# UNITED STATES PATENT AND TRADEMARK OFFICE

## Office Action Summary

09/989,271

SMYK, MICHAEL C.

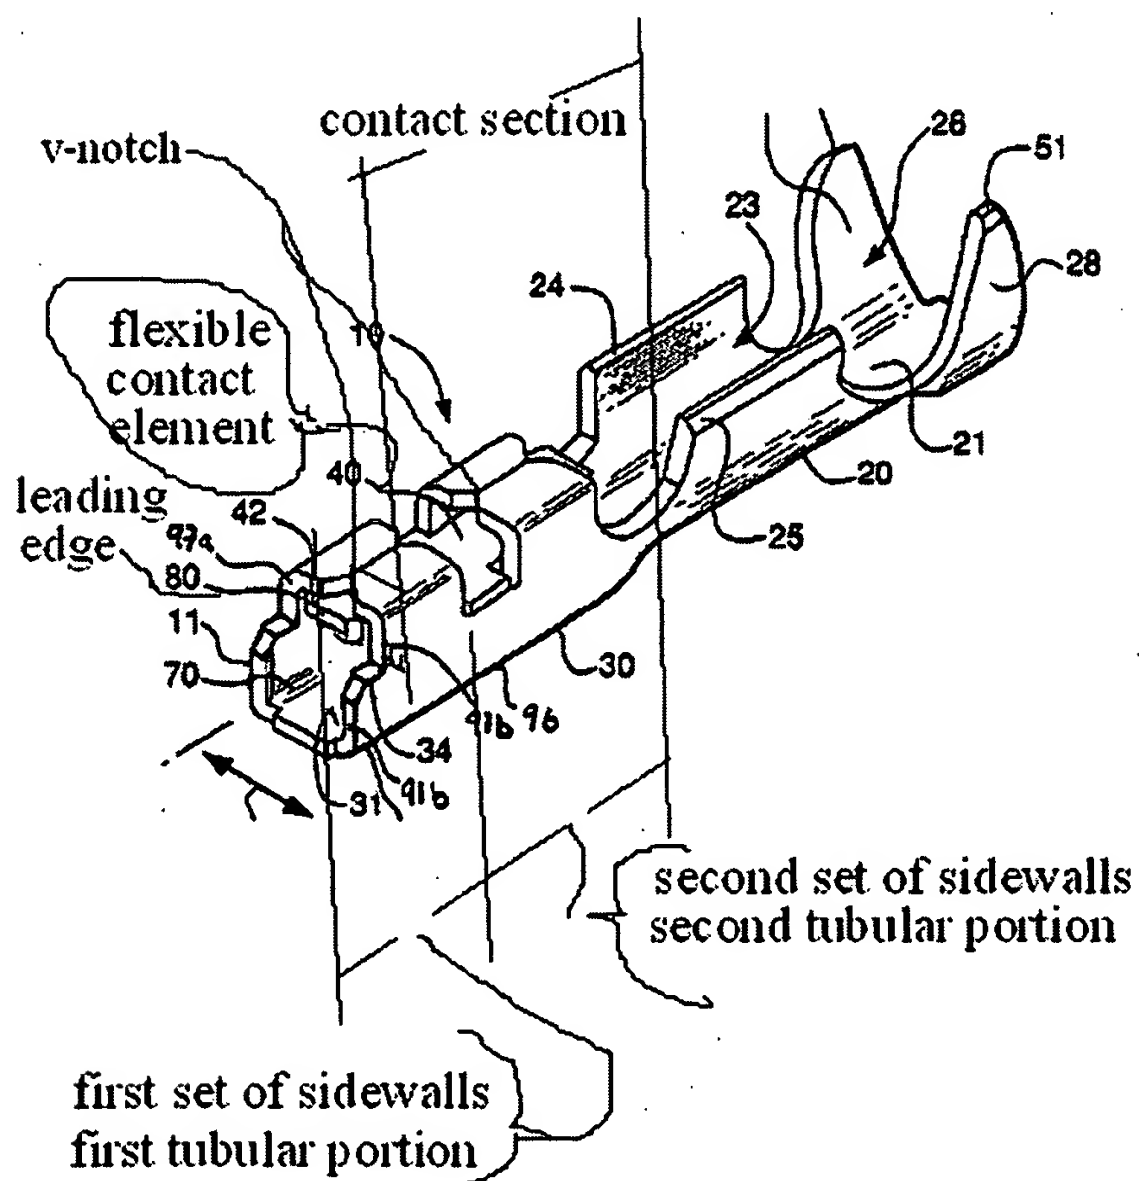
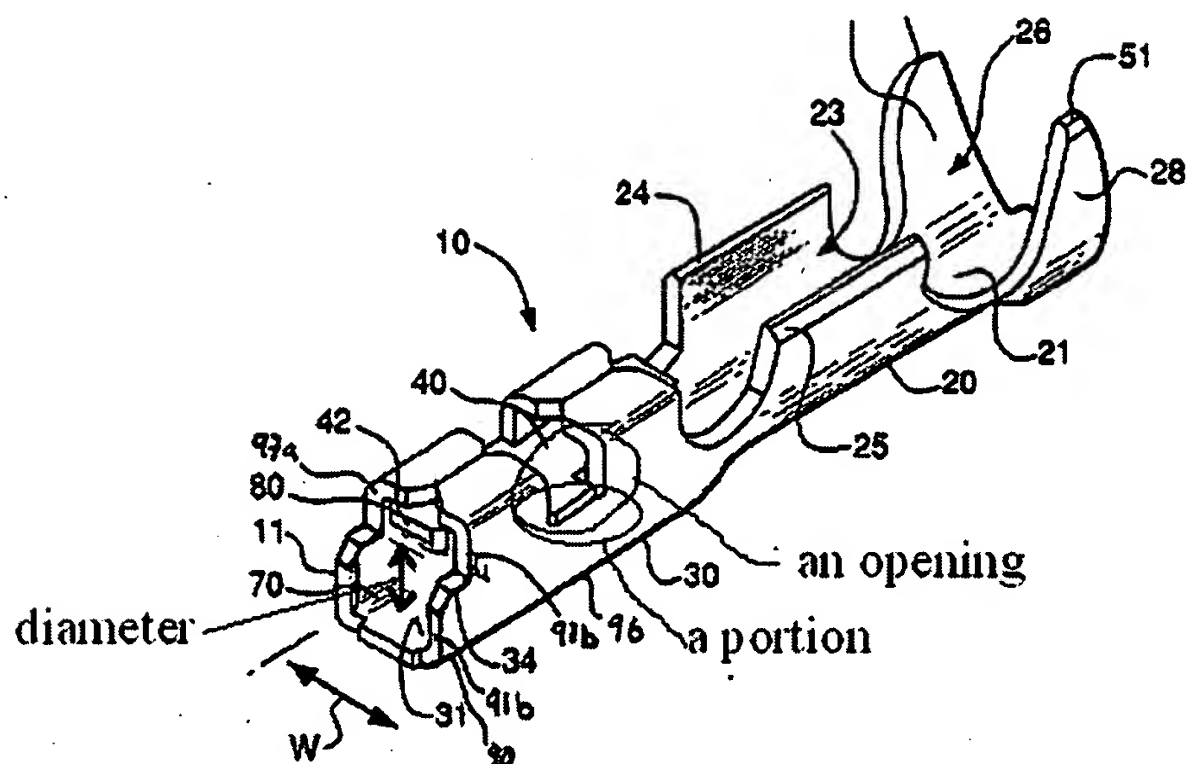
-- In reference to Claim(s) 45, FCI shows (see examiner's figure)

a contact section for mating with a complementary male terminal, the contact section including a bottom wall;

a first set of sidewalls 18 that define a first tubular portion with the bottom wall; and a second set of sidewalls 14, which are longer than the first set of sidewalls, that define a second tubular portion with the bottom wall, the second tubular portion arranged end to end with the first tubular portion; and

a flexible contact element 10 at least partially disposed within the contact section in a non-fixedly secured manner for urging a complementary male terminal into engagement with the bottom wall.

-- In reference to the recitation "wherein the flexible contact element is not attached to the contact section when the female electrical terminal is mated with a complementary male terminal", FCI is seen to show the same structure that captures the contact element within the mating portion of the terminal and makes the recitation unpatentable.

-- In reference to Claim(s) 46, FCI shows (see examiner's figure) the flexible contact element includes a leading edge (see examiner's figure) that is positioned outside of the contact section.

-- In reference to Claim(s) 47, FCI shows (cover sheet) the flexible contact element includes a leading edge (see examiner's figure), and wherein the female electrical terminal is devoid of any structure prohibiting frontal access to the flexible contact element leading edge (see examiner's figure).

-- In reference to Claim(s) 51, FCI shows (see examiner's figure) an opening (see examiner's figure) is defined at an interface between the first tubular portion and the second tubular portion; and a portion (see examiner's figure) of the flexible contact element extends into the opening.

the first tubular portion has an effective diameter (see examiner's figure) that is a different size than that of the second tubular portion; and

a contact section including a set of converging sidewalls ( first tubular portion ) that define an insertion pathway for a complementary male terminal, the insertion pathway having a diameter (see examiner's figure) that is smaller than a tubular portion (second tubular portion) that is proximate the set of converging sidewalls; and
